## **ADDENDUM NO. 2**

Issued: October 25, 2016

Project: Joplin Early Childhood Center  
Site Legal Description:  
JOP MISC  
BEG 1360.93' S & 50' E NW  
COR SE E 456.91' N 318.78'  
W 456.91' S 318.78' TO POB

Project No. 16054

**A202**

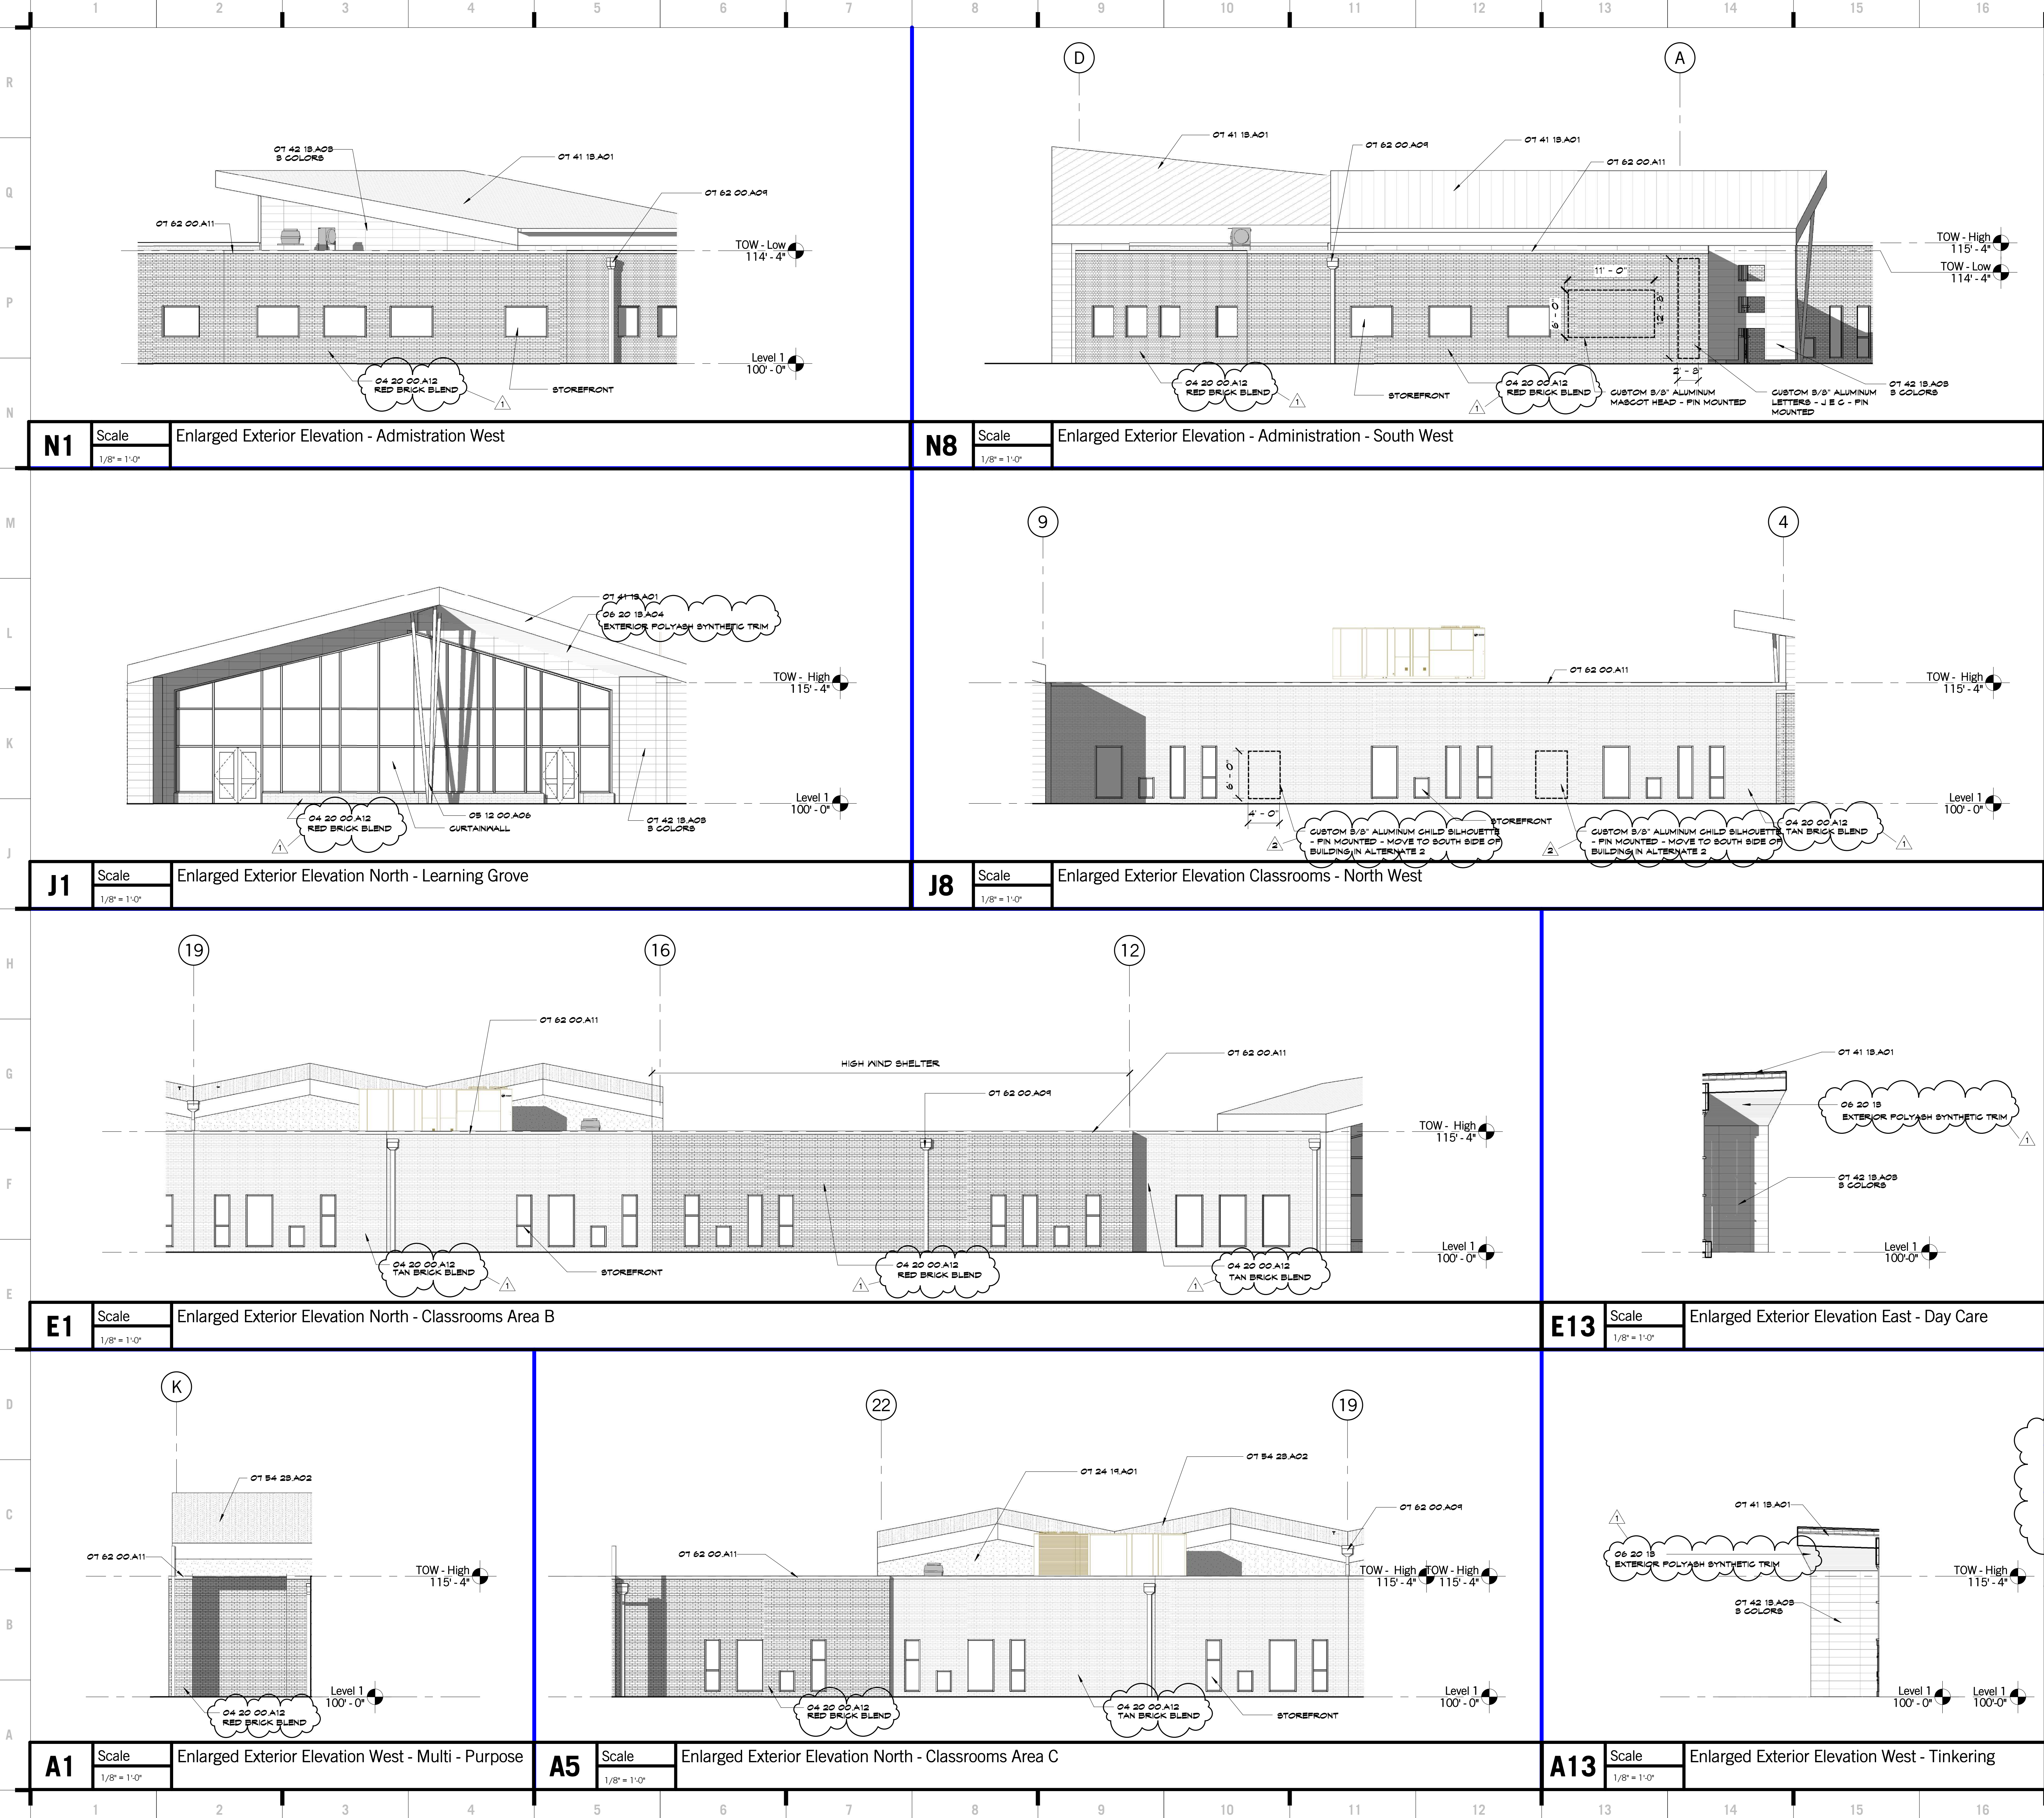
A24.1 REPLACE previously issued Sheet A202 in Addendum 1, with attached sheet A202 dated 10.25.2016. (Clarify EIFS system notes and custom aluminum sheet signage).).

**A625**  
\_\_\_\_ OF \_\_\_\_

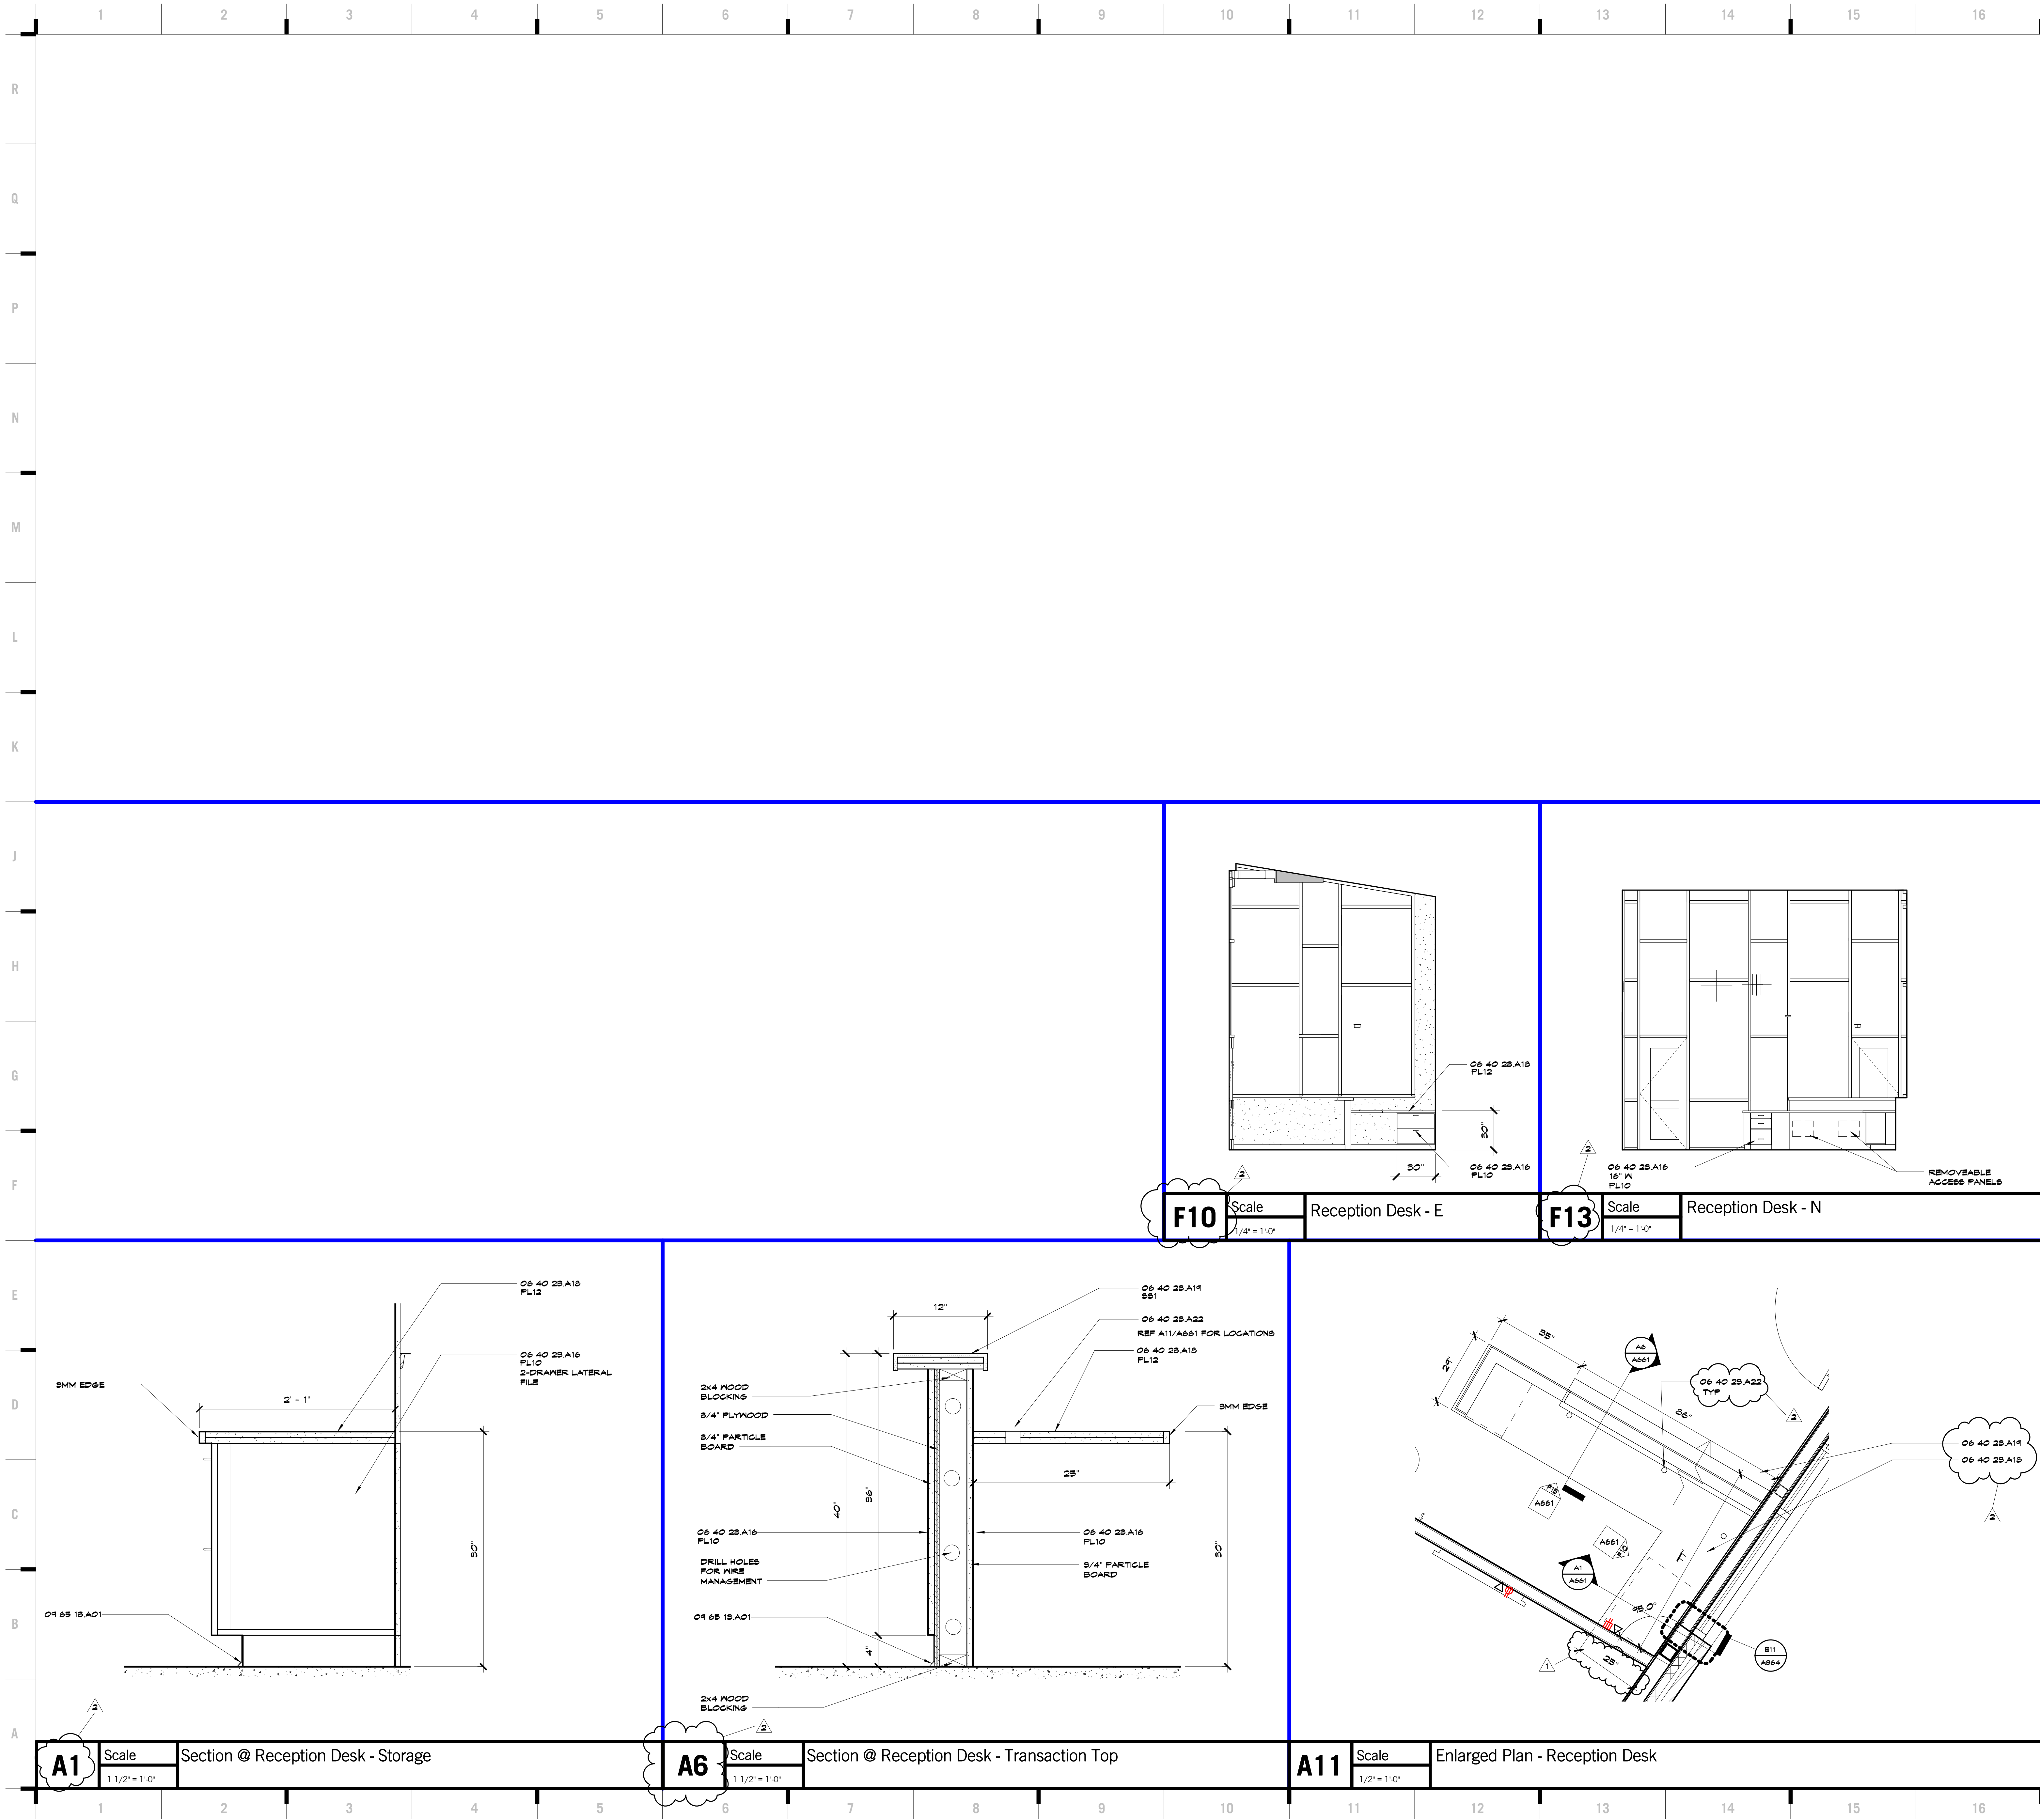
A37.1 REPLACE previously issued Sheet A625, with attached sheet A625 dated 10.25.2016. (Sheet Note: Hollow Metal Frame Paint Colors: REPLACE note 6 with paint color Marine Blue #88GG 32/346 and note 7 with paint color Indian Bead #70BG 31/332, Elevation A10: ADD text “PAINTED WOOD FRAMES – PROFILE AND SIZES TBD. ATTACHED CABLES & HOOKS” under keynote 06 40 23.A02, ADD elevations E7 and E10, Elevation A1 - ADD plastic laminate designation under associated keynotes, Elevation A6 – ADD plastic laminate designation under associated keynotes. CHANGE casework dimensions and Elevation E13 – ADD plastic laminate designation under associated keynote).
